CITY OF MORRO BAY PLANNING COMMISSION AGENDA

B-1 **Case No.:** CP0-408

Site Location: 1000 Ridgeway

TO: Planning Commissioners **DATE:** February 13, 2014

EXHIBIT G

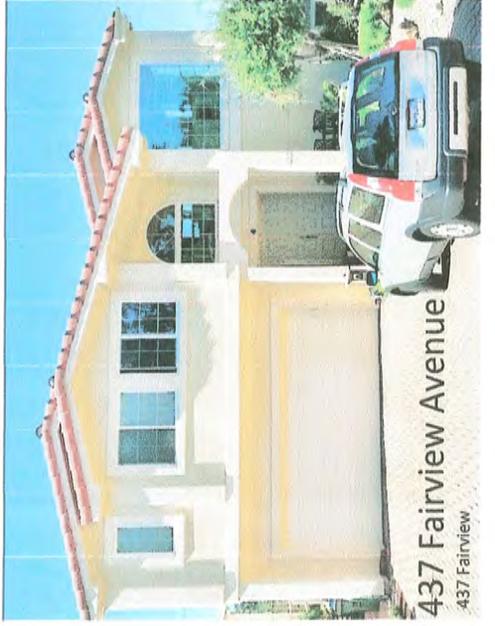
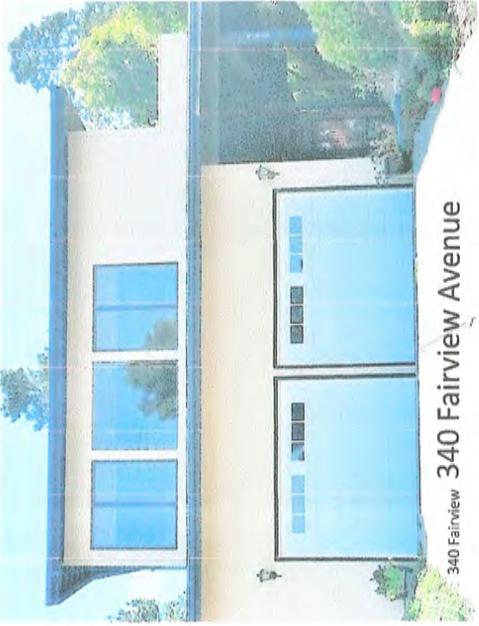
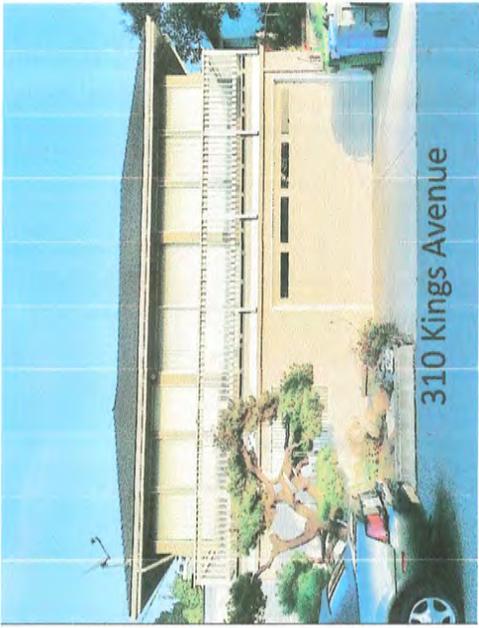
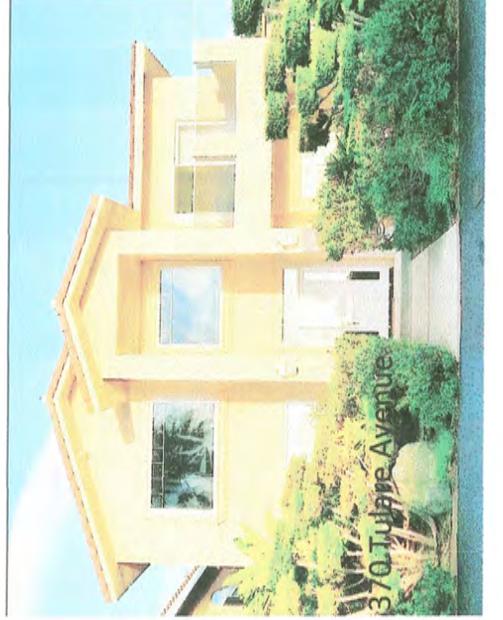
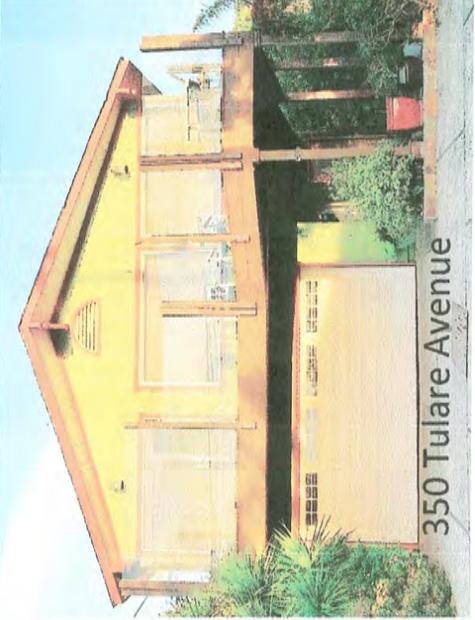
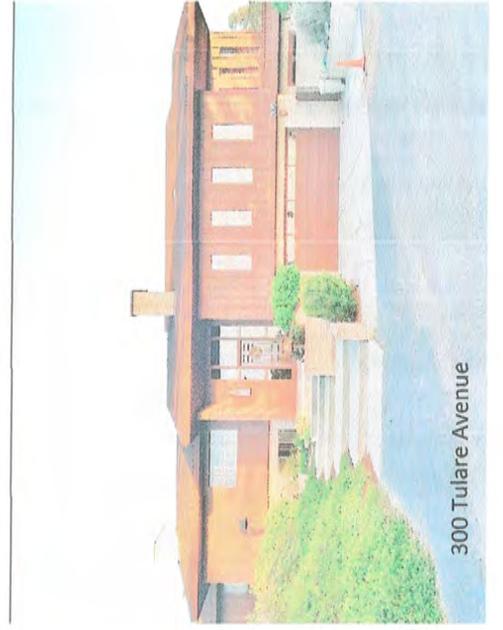
Staff response: The project as proposed is the demolition and reconstruction of an existing one story single family home to a two story home within the setbacks, lot coverage and maximum

building height on a previously developed private property. The Applicant has submitted photographic architectural renderings which show the project's character and scale with the surrounding architecture of the neighborhood. There is no evidence to support the claim the structure would loom out of proportion to all existing structures in the area because the proposed project is a two story home in an established neighborhood of two story homes (See attached Exhibit G).

EXHIBIT G

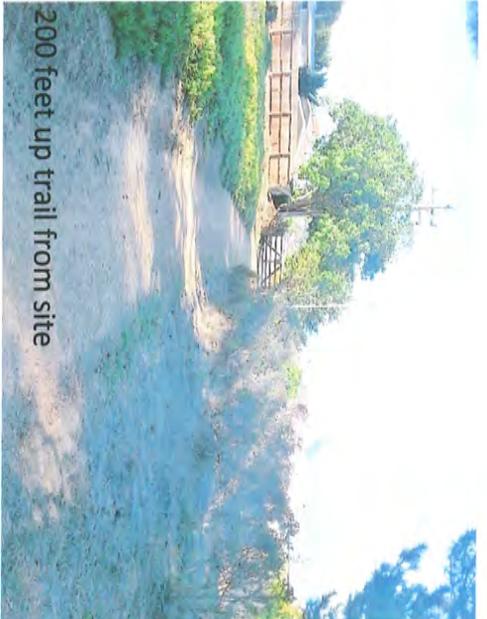
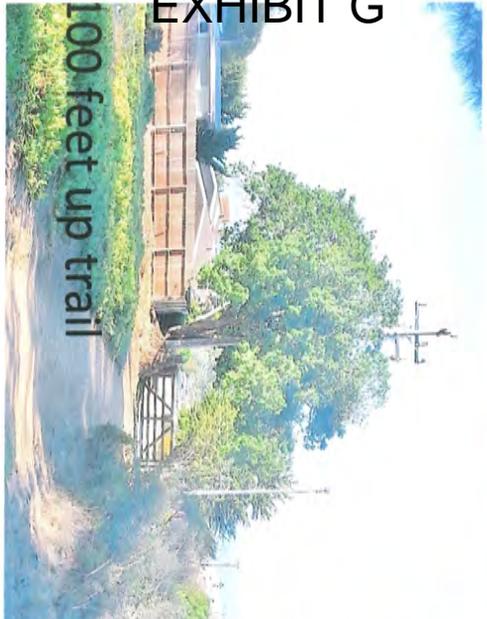
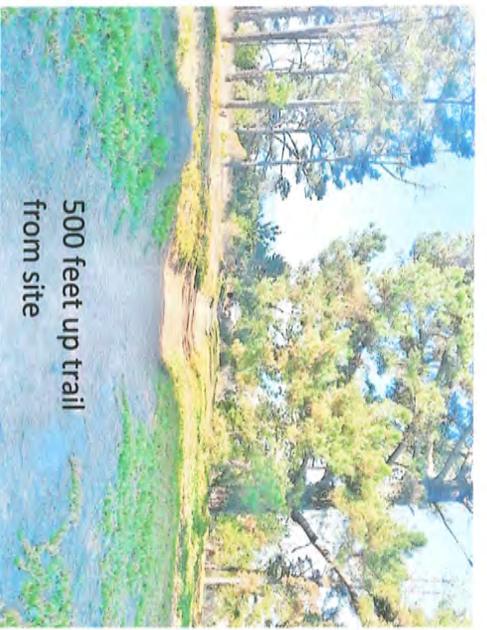
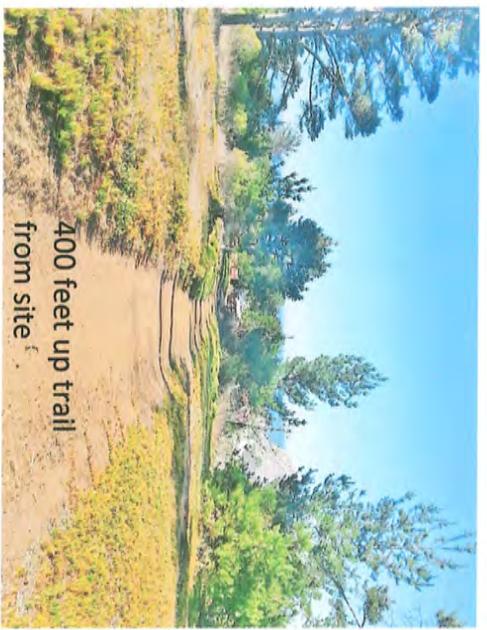
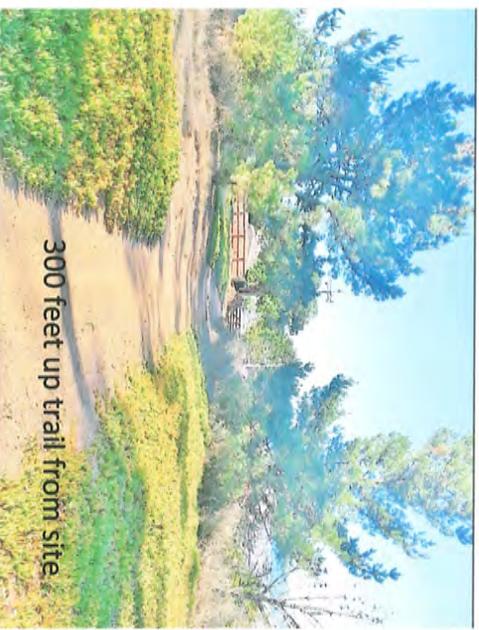
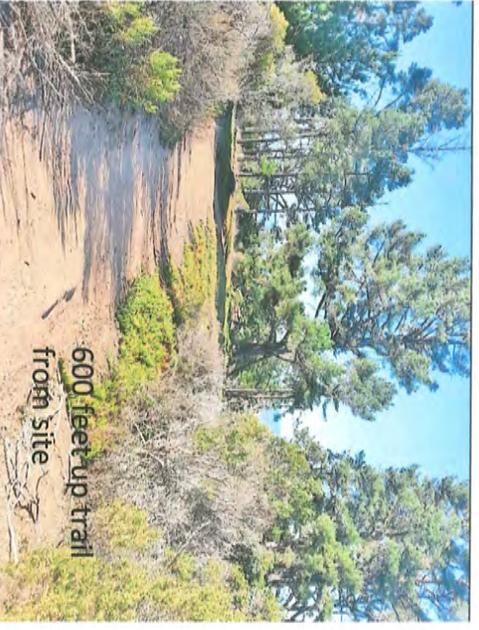
Appeal Issue #3: *“Visual Resources Policy 12.02 provides that permitted developments shall be sited and designed to protect views to and along the coast. As stated above, the view of the coastline and Morro Rock from the State Park trail would be negatively impacted by this development. Policy 12.02 further provides that permitted developments shall be visually compatible with the surrounding areas. While there is a not yet specific design criterion for this area, it is clear from the plans that this proposed residence is incompatible with its neighborhood in design and square footage.”*

Staff response: The proposed development at 1000 Ridgeway is a previously developed site. The demolition of the existing single family home and reconstruction of a two story single family home has been found to be within the residential development standards for maximum height, maximum lot coverage and within allowed setbacks. The views of the coastline and Morro Rock would not be negatively impacted by the proposed development. The proposed project as a two story home is consistent with other two homes within this planning area. The Applicant has submitted a photo exhibit showing the viewpoints from various vantage points along the Black Hill Natural Area which are attached as an Exhibit.
